HISTORIC AND DESIGN REVIEW COMMISSION

May 02, 2018

HDRC CASE NO: 2017-544
ADDRESS: 313 E LOCUST
LEGAL DESCRIPTION: NCB 1738 BLK 3 LOT 3, EXC W 2 FT OF S 116.7 FT
ZONING: C-2 H
CITY COUNCIL DIST.: 1
DISTRICT: Tobin Hill Historic District
APPLICANT: Robert Moritz/DHR Architects
OWNER: GCM Holdings, Inc
TYPE OF WORK: Final approval for construction of two, 2-story duplexes
APPLICATION RECEIVED: April 13, 2018
60-DAY REVIEW: June 12, 2018
REQUEST:

The applicant is requesting a Certificate of Appropriateness for approval to construct two, 2-story duplex structures on the vacant lot located at 313 E Locust.

SETBACK EVALUATION

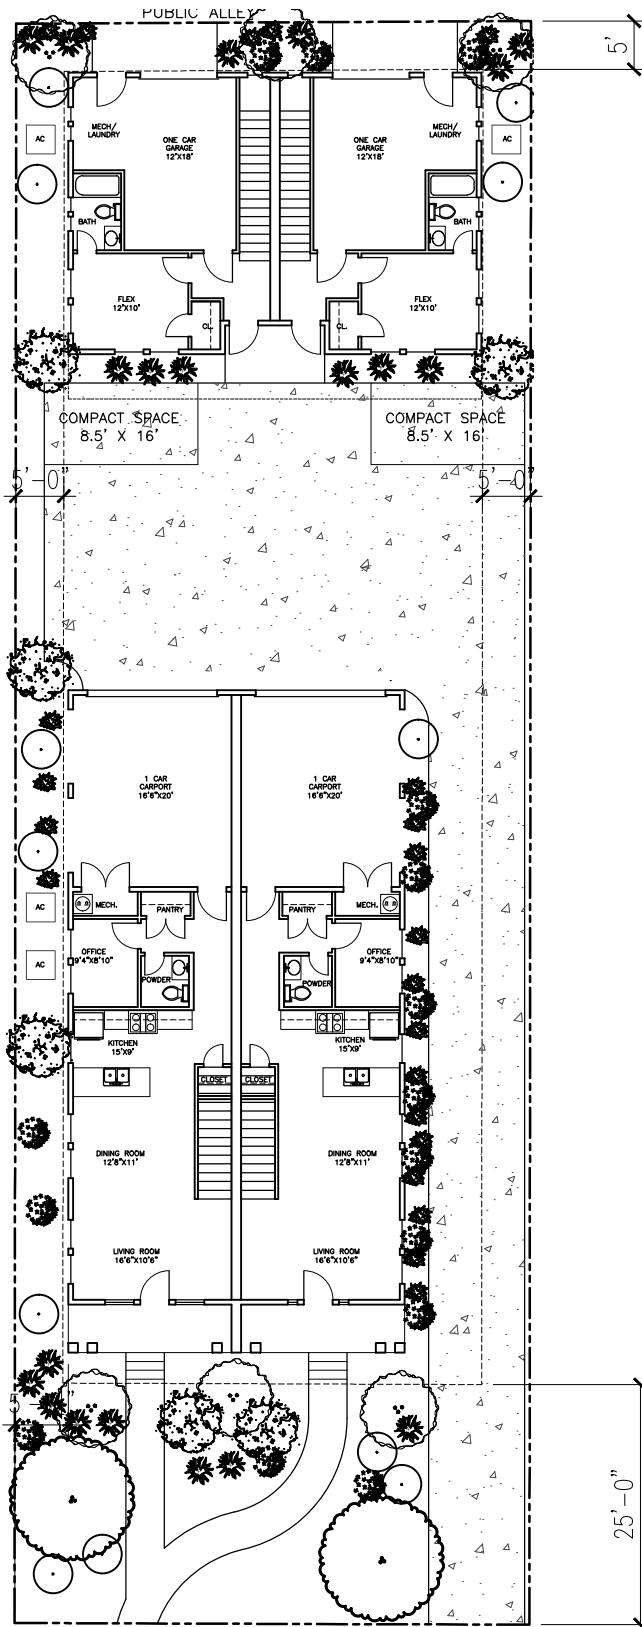
1. That the applicant increases the setback of the front unit to be more consistent with the adjacent 2-story historic structure as noted in finding e; **this stipulation has not been met.**

- e. **SETBACKS** – According to the Guidelines for New Construction, the front facades of new buildings are to align with front facades of adjacent buildings where a consistent setback has been established along the street frontage. This block of E Locust contains historic structures that feature front yard setbacks of approximately 20-35 feet. Based on the submitted documentation, the neighboring historic structure to the east has a front setback of 32.11 feet. The historic 1-story structure two lots down has a setback of approximately 18.24 feet. The applicant has proposed a setback of approximately 28.27 feet. While the proposed setback is greater than the median between those of the historic structures that exist on the same block of E Locust, its placement would be approximately seven feet closer to the sidewalk than the historic structure immediately adjacent to the east. Staff finds that the setback should be increased to be compatible with the immediate context of the block.

- i. That the applicant increases the front setback to measure at least 30 feet from the property line as measured to the front plane of the building. The applicant is required to submit an updated site plan that reflects this change to staff for review and approval prior to receiving a Certificate of Appropriateness.

FRONT UNIT
AND FLOOR PLANS

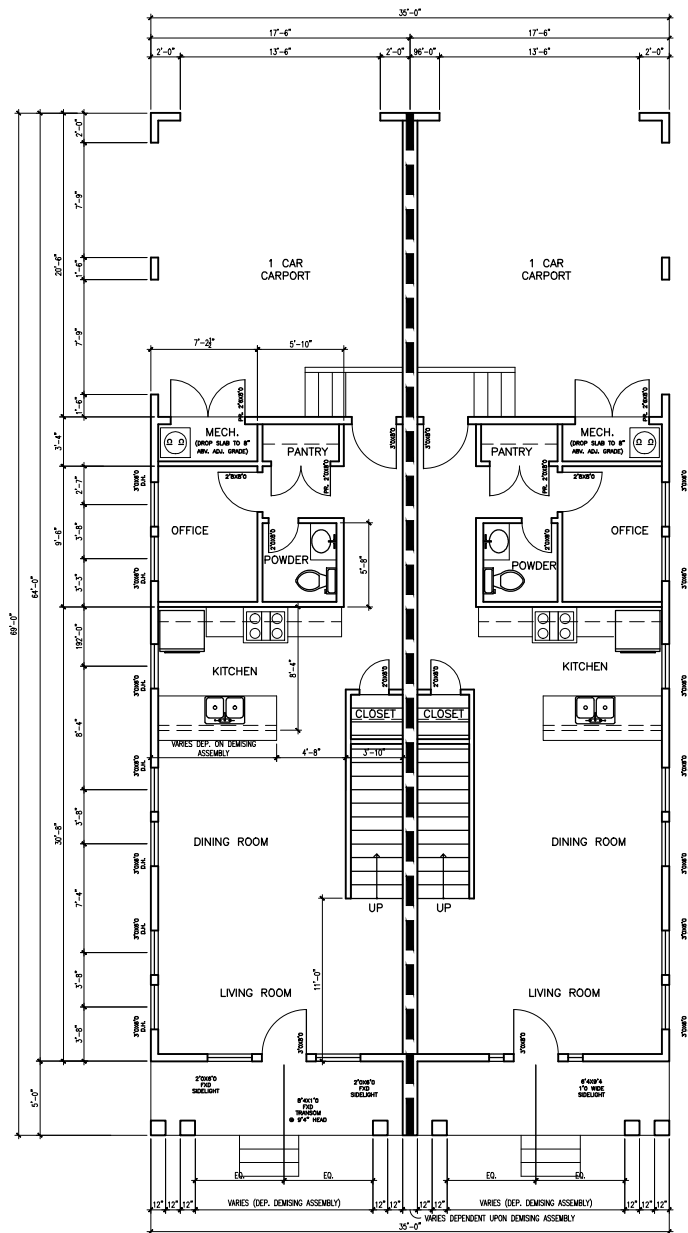
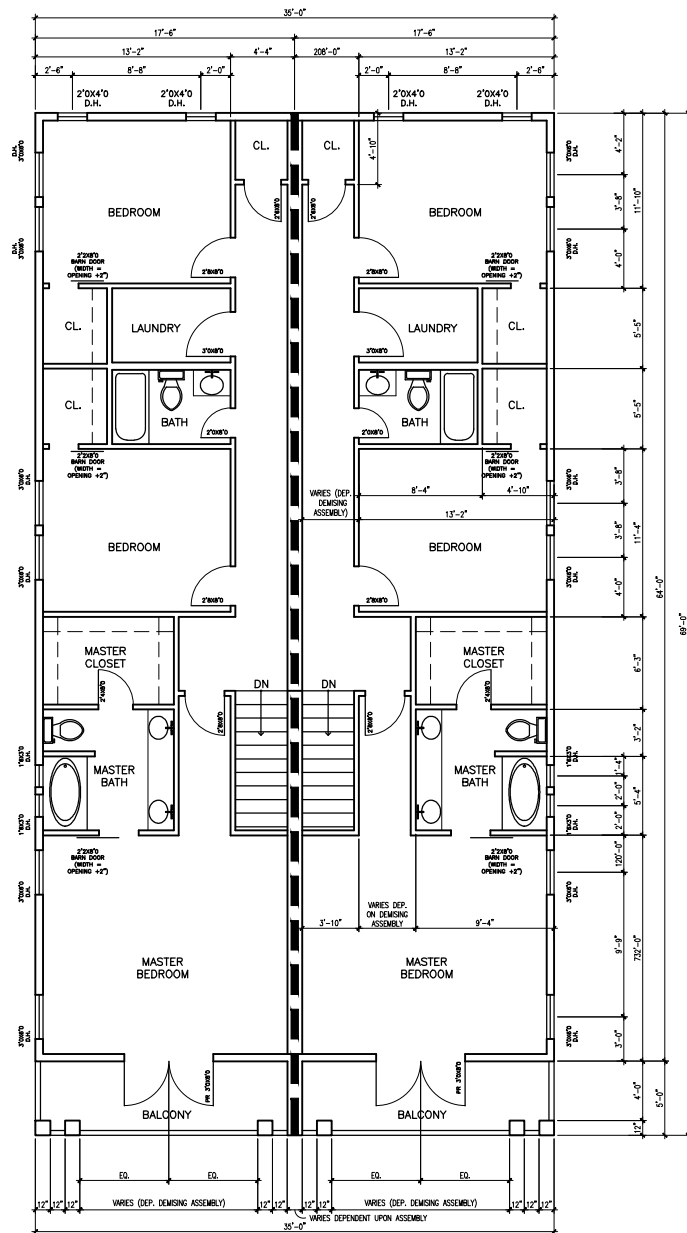
3. That the applicant modifies the proposed entryway configurations to be more consistent with transoms and side lites found on historic precedents in the district as noted in finding j; **this stipulation has not been fully met.**

- j. **WINDOW & DOOR OPENINGS** – According to the Historic Design Guidelines for New Construction, window openings with a similar proportion of wall to window, as compared to nearby historic facades, should be incorporated. Similarity is defined by windows that are no larger than 25% in size and vary no more than 10% in height to width ratio from adjacent historic facades. The applicant has proposed several window and door openings that generally feature sizes that are found on historic structures. However, the entry doors feature transom and side lite configurations that are not found historically in the district. Staff finds that the configuration should be modified to more closely match those rooted in historic precedents.

- ii. That the front doors feature side lite and transom configurations that are more consistent with historic precedents and proportions. The applicant is required to submit final specifications and drawings for both entryways to staff for review and approval prior to receiving a Certificate of Appropriateness.

FRONT UNIT
ELEVATIONS

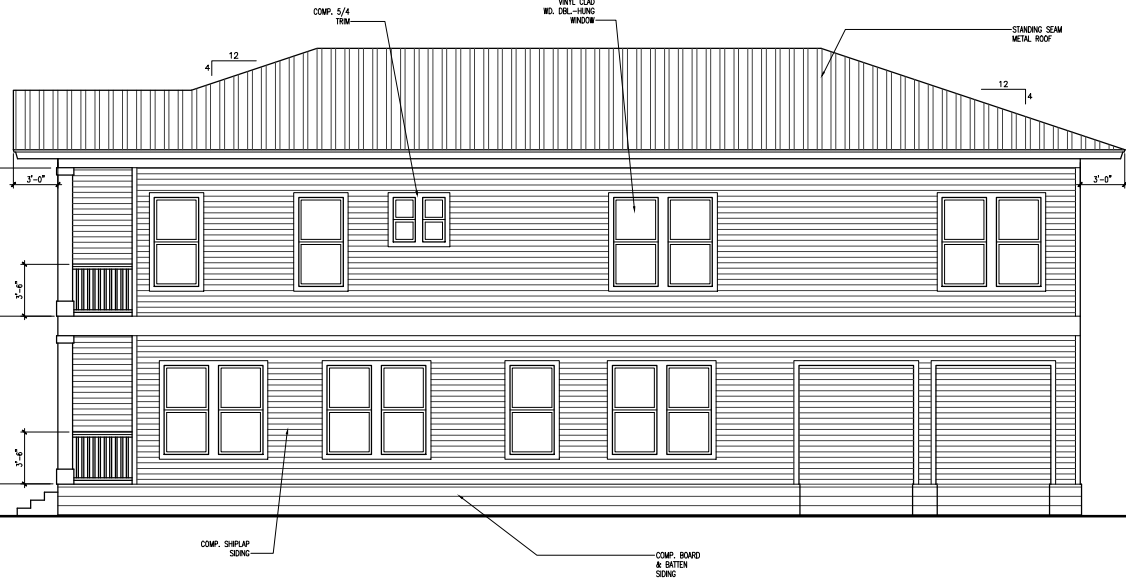
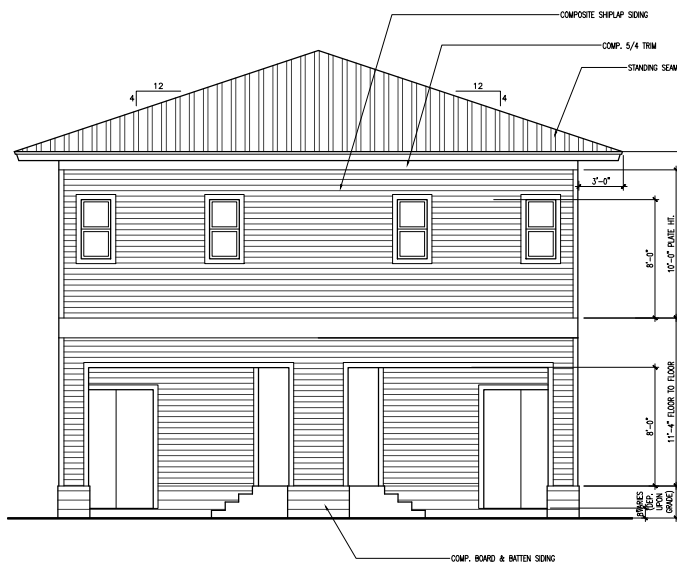
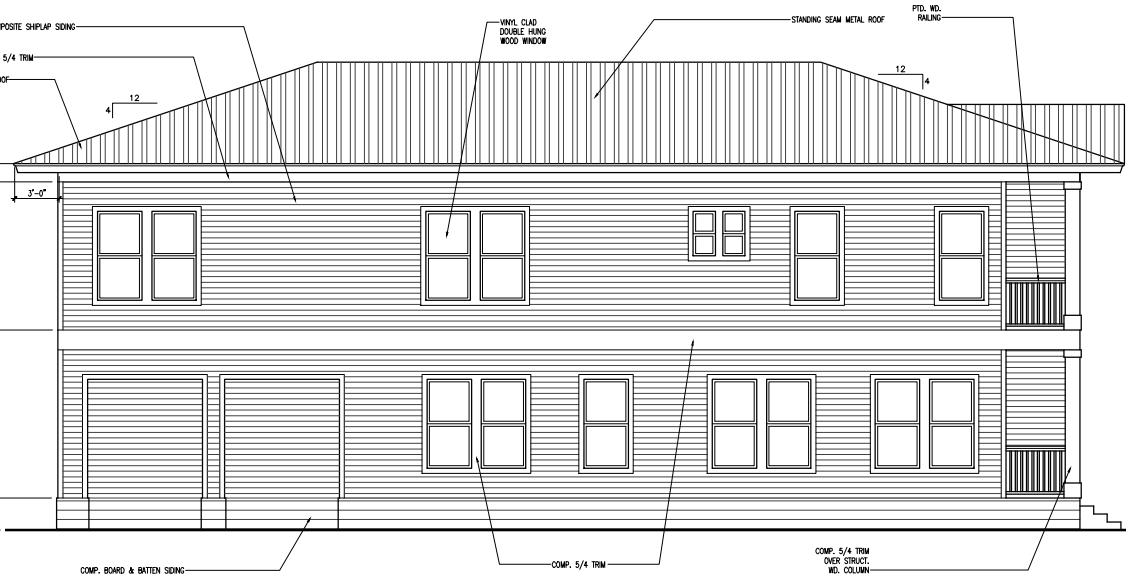
- g. **SCALE & MASS** – The applicant has proposed two 2-story units. One will be located along the street frontage of E Locust and one will be located at the rear of the property, directly adjacent to an existing alley. Per the submitted elevations, the ridgeline of the front 2-story unit is 31'-6 ¾". The ridgeline of the rear unit is 28'-10 ¾". Guideline 2.A.i stipulates that the height and scale of new construction should be consistent with nearby historic buildings and should not exceed that of the majority of historic buildings by more than one-story. Per the submitted elevations, the applicant has indicated that the 2-story historic structure directly to the east is approximately 35'-4" in height. The rear 2-story structure does not overwhelm existing alleyway structures in terms of height.

- h. **FOUNDATION & FLOOR HEIGHTS** – According to the Guidelines for New Construction 2.A.iii., foundation and floor heights should be aligned within one (1) foot of neighboring structure's foundations. Throughout this block, the foundation heights of primary historic structures are between two and three feet. The elevations for the front unit indicated a foundation height of approximately 2'-2" (26 inches). Staff finds that the front unit has a foundation height consistent with the Guidelines.

- iii. That the applicant installs aluminum-clad wood windows in lieu of the proposed vinyl. The applicant is required to submit a final window specification for the proposed aluminum-clad wood windows to staff for review and approval. Meeting rails must be no taller than 1.25” and stiles no wider than 2.25”. White manufacturer’s color is not allowed, and color selection must be presented to staff. There should be a minimum of two inches in depth between the front face of the window trim and the front face of the top window sash. This must be accomplished by recessing the window sufficiently within the opening or with the installation of additional window trim to add thickness. Window trim must feature traditional dimensions and architecturally appropriate sill detail. Window track components must be painted to match the window trim or concealed by a wood window screen set within the opening.
